NORTHEAST NUCLEAR ENERGY COMPANY
THE CONNECTICUT LIGHT AND POWER COMPANY
THE WESTERN MASSACHUSETTS ELECTRIC COMPANY
DOCKET NO. 50-336
MILLSTONE NUCLEAR POWER STATION, UNIT NO. 2
AMENDMENT TO FACILITY OPERATING LICENSE

Amendment No. 99
License No. DPR-65

ATTACHMENT TO LICENSE AMENDMENT NO. 99

**FIGURE 3.2-2a AXIAL SHAPE INDEX vs FRACTION OF ALLOWABLE POWER LEVEL
per Specification 4.2.1.2c**

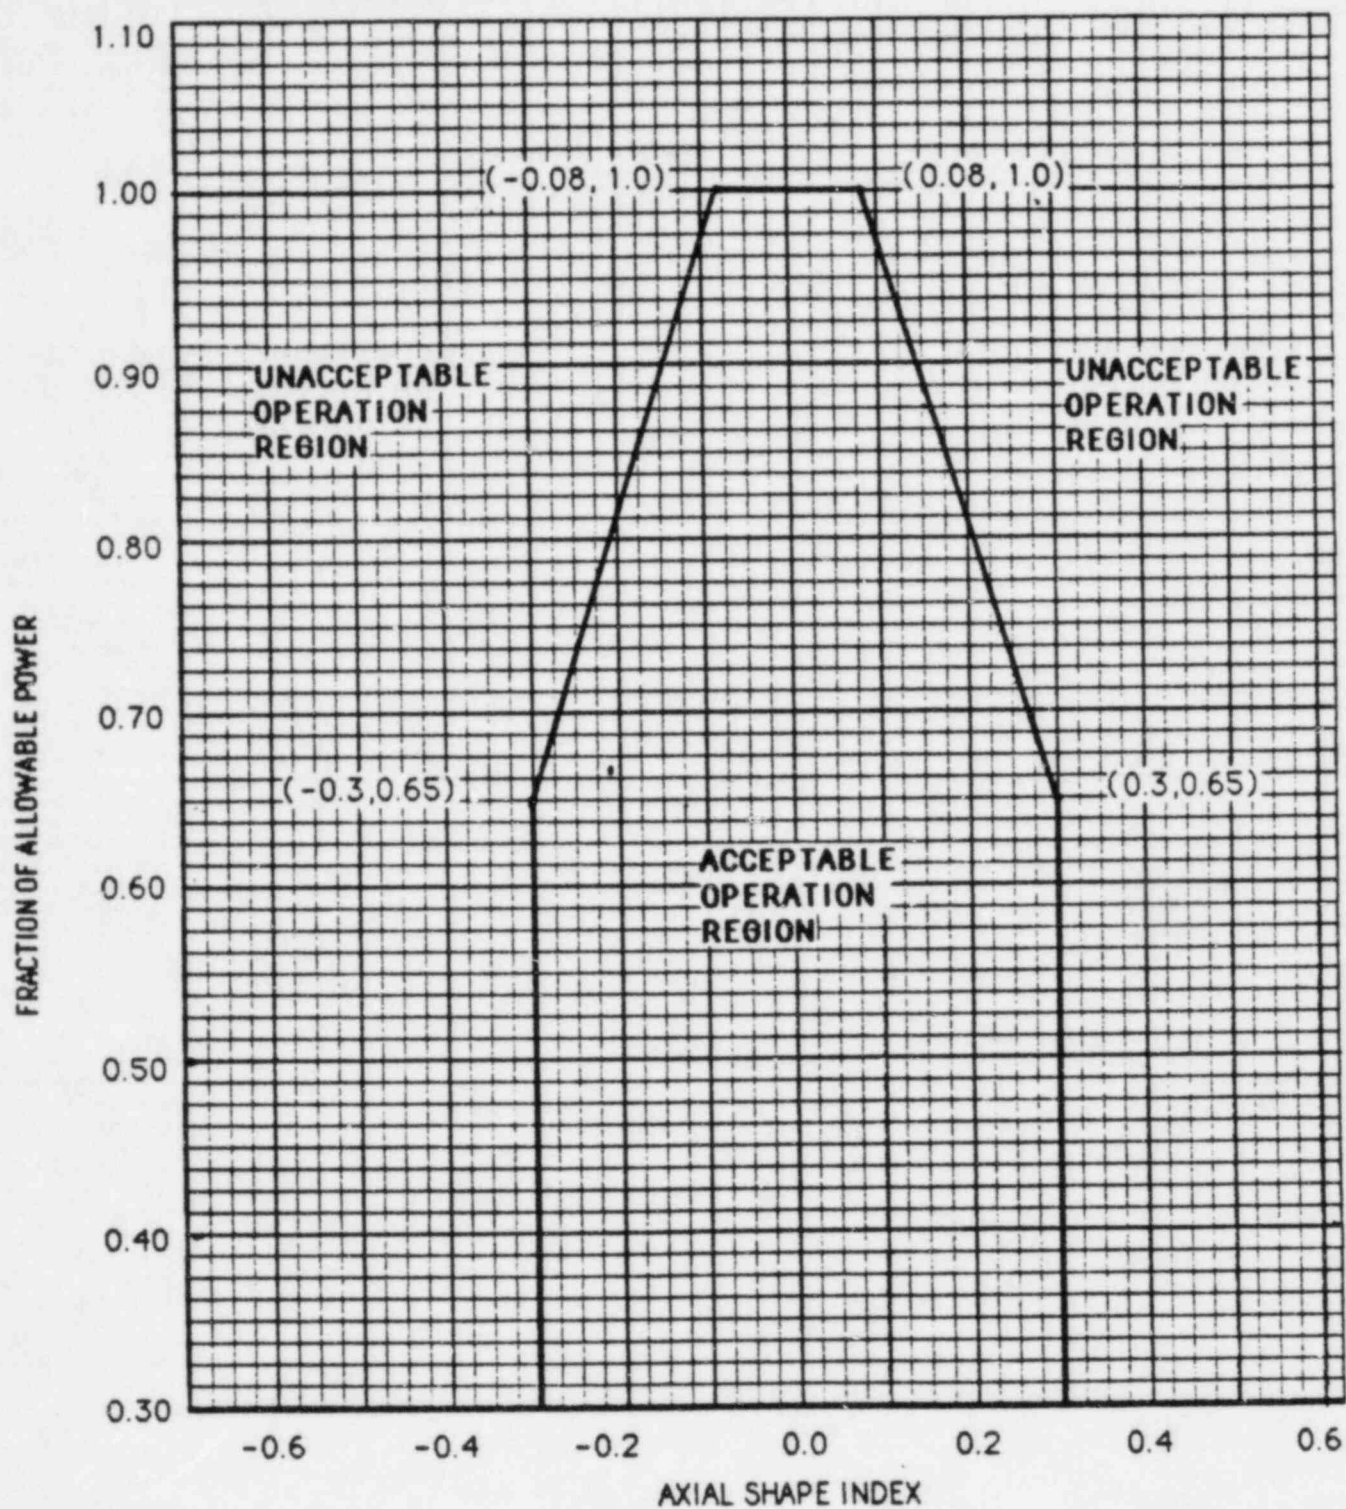
3.2.2.1 The calculated value of F_{xy}^T , defined as $F_{xy}^T = F_{xy} (1+T_q)$, shall be limited to ≤ 1.62 with the AXIAL SHAPE INDEX alarm setpoints adjusted consistent with the limits shown on Figure 3.2-2a, or

- a. With $F_{xy}^T > 1.62$ and the AXIAL SHAPE INDEX alarm setpoints adjusted consistent with the limits shown on Figure 3.2-2a, within 6 hours either:

FIGURE 3.2-2b AXIAL SHAPE INDEX vs FRACTION OF ALLOWABLE POWER LEVEL |
per Specification 4.2.1.2c

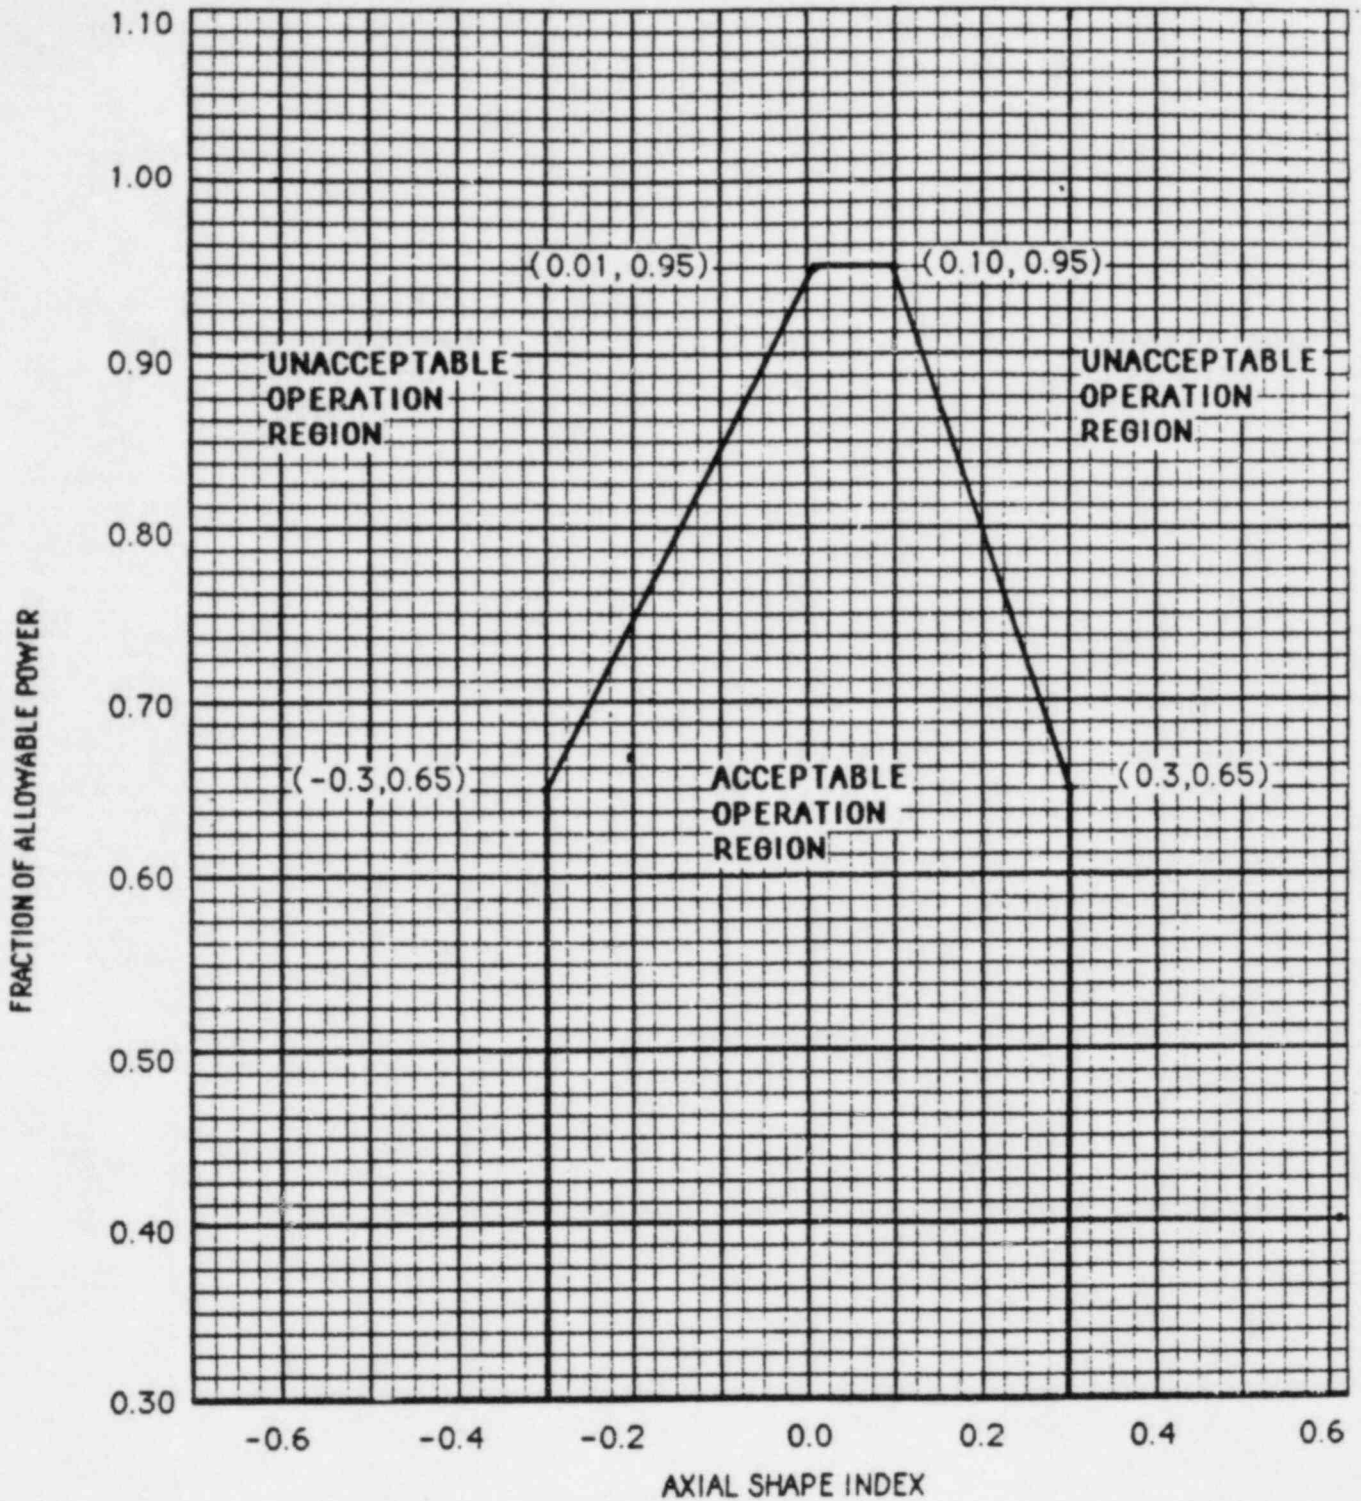
3.2.2.2 The calculated value of F_{xy}^T , defined as $F_{xy}^T = F_{xy} (1+T_q)$, shall be limited to ≤ 1.719 with the AXIAL SHAPE INDEX alarm setpoints adjusted consistent with the limits shown on Figure 3.2-2b.

- 2) Apply the limits of Specification 3.2.2.2 and Figure 3.2-3b and within 72 hours adjust the AXIAL SHAPE INDEX alarm setpoints consistent with the limits shown on Figure 3.2-2b, or

- 3) Be in at least HOT STANDBY.
- b. With $F_{xy}^T > 1.719$ and the AXIAL SHAPE INDEX alarm setpoints adjusted consistent with the limits shown on Figure 3.2-2b, within 6 hours either:

FIGURE 3.2-3a Total Radial Peaking Factor vs Allowable Fraction of Rated Thermal Power

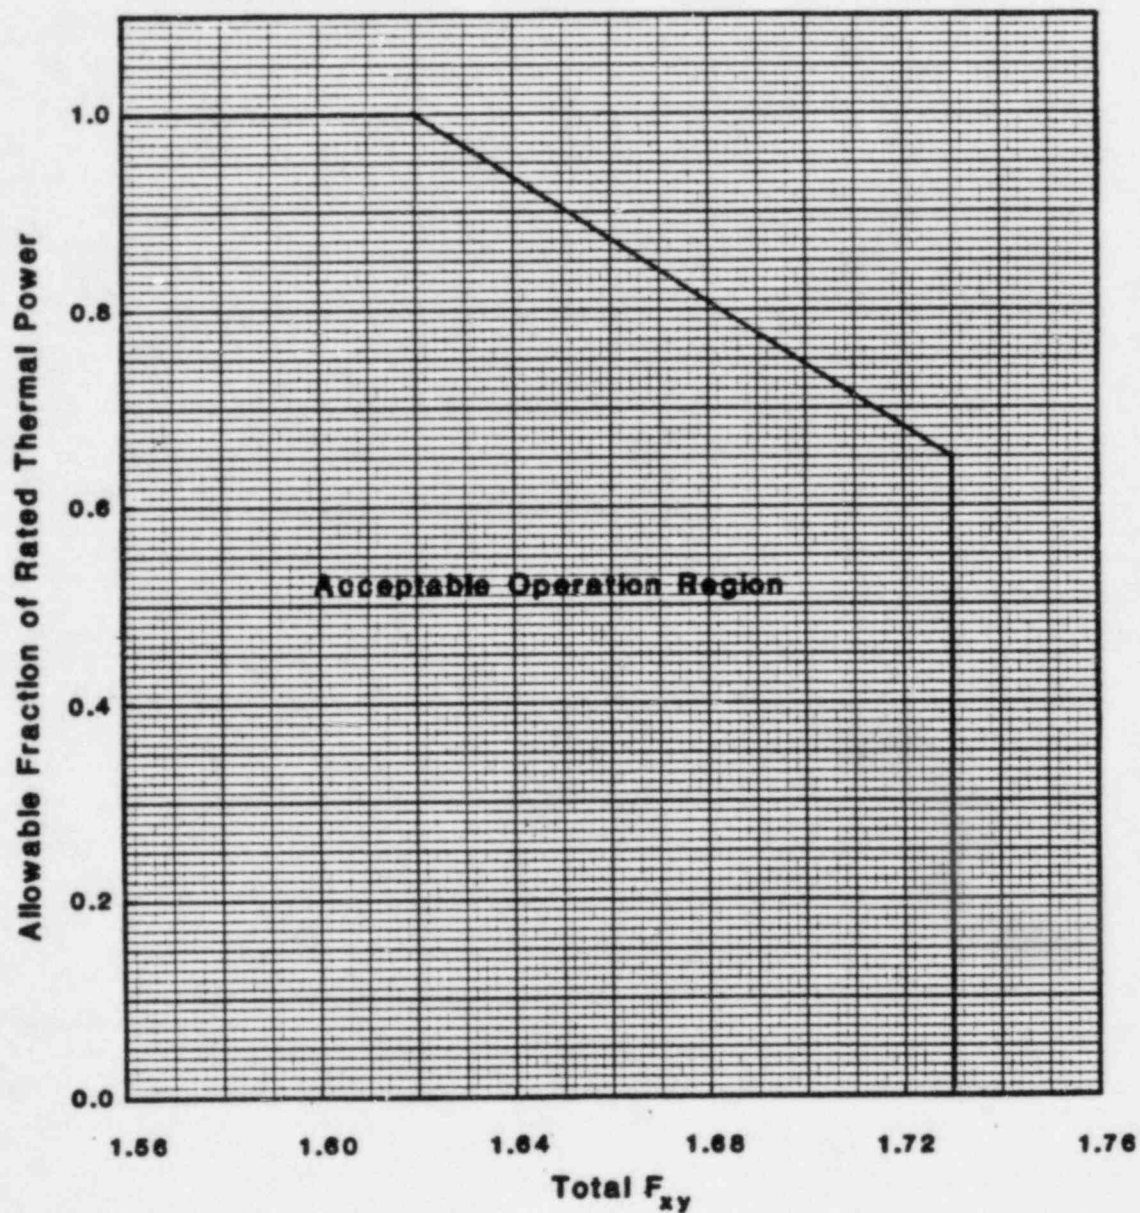
- 1) Reduce THERMAL POWER to bring the combination of THERMAL POWER and F_{xy}^T to within the limits of Figure 3.2-3a and withdraw the full length CEAs to or beyond the Long Term Steady State Insertion Limit of Specification 3.1.3.6, or

FIGURE 3.2-3b Total Radial Peaking Factor Versus Allowable Fraction of Rated Thermal Power

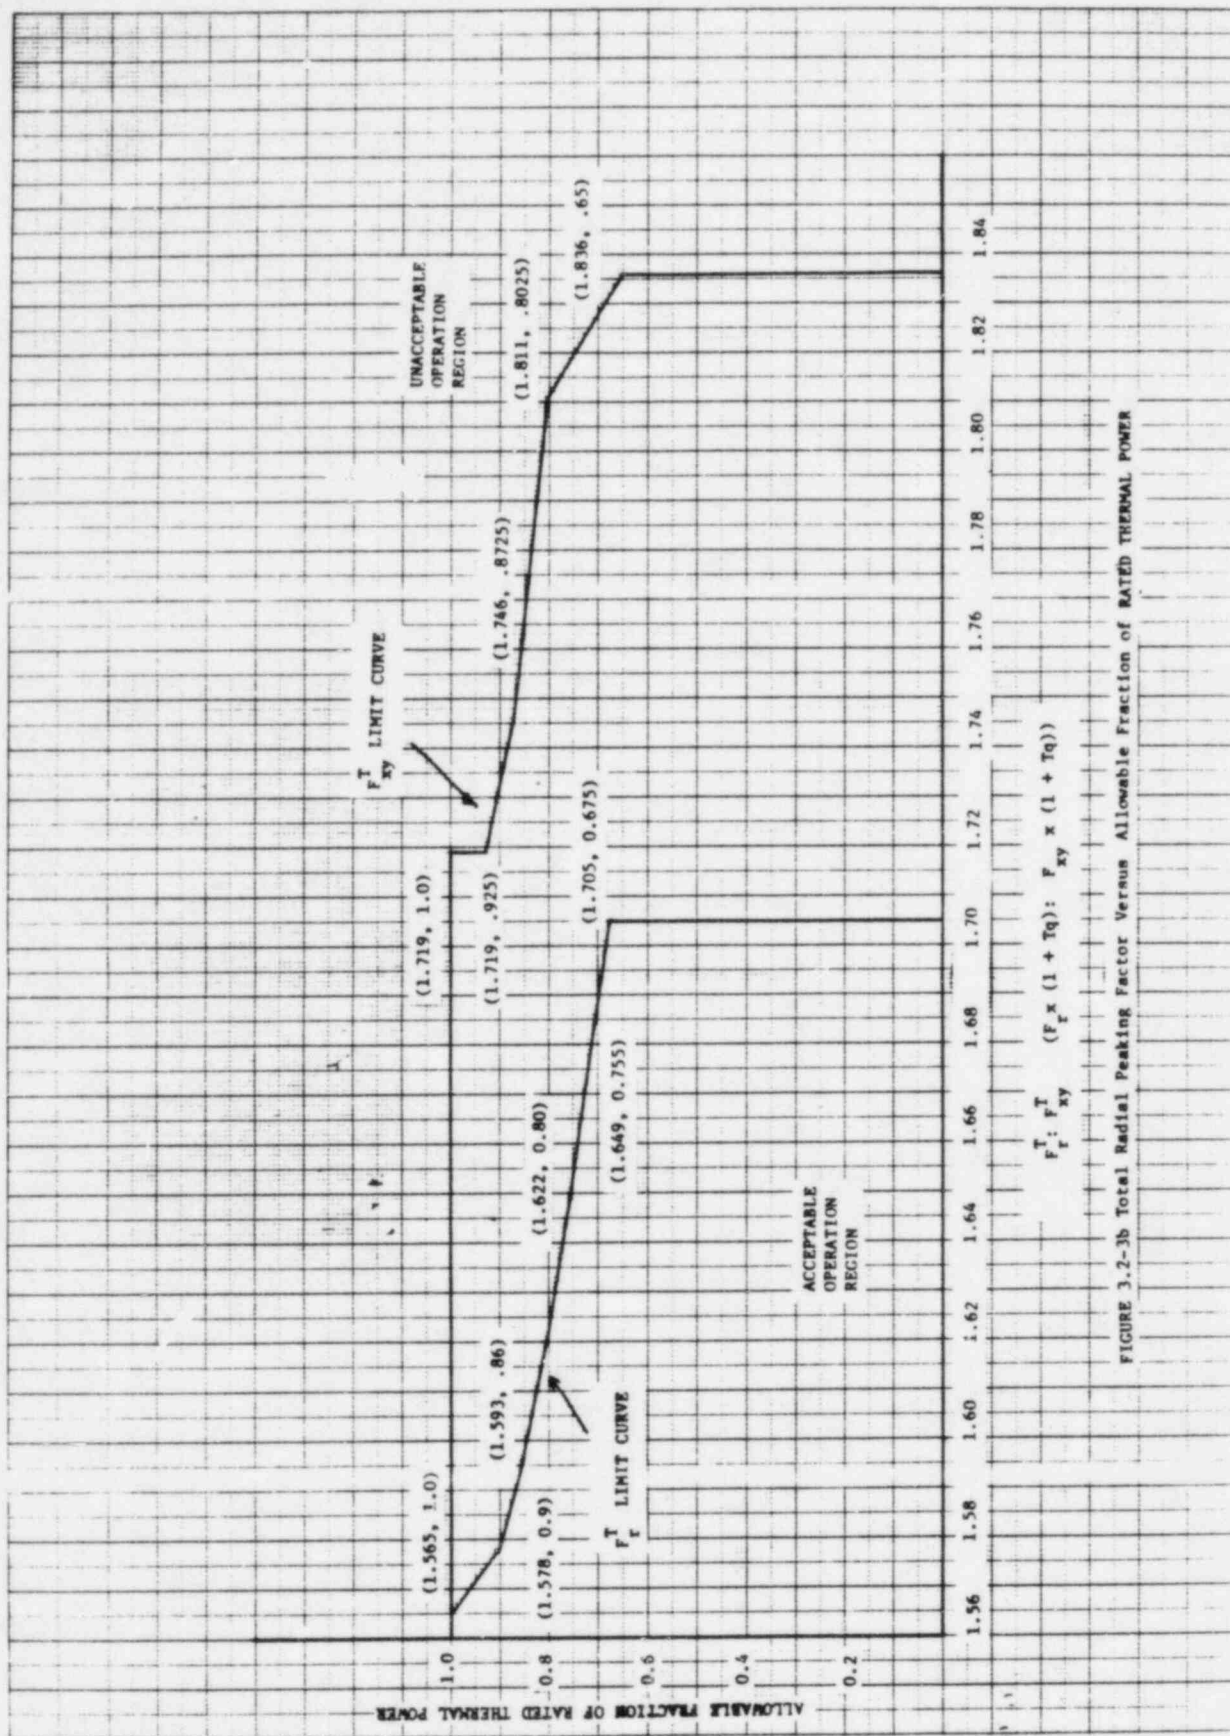
- 1) Reduce THERMAL POWER to bring the combination of THERMAL POWER and F_{xy}^T to within the limits of Figure 3.2-3b and withdraw the full length CEAs to or beyond the Long Term Steady State Insertion Limit of Specification 3.1.3.6, or

- a. Reduce THERMAL POWER to bring the combination of THERMAL POWER and F_r^T to within the limits of Figure 3.2-3b and withdraw the full length CEAs to or beyond the Long Term Steady State Insertion Limits of Specification 3.1.3.6; or
- b. Be in at least HOT STANDBY.
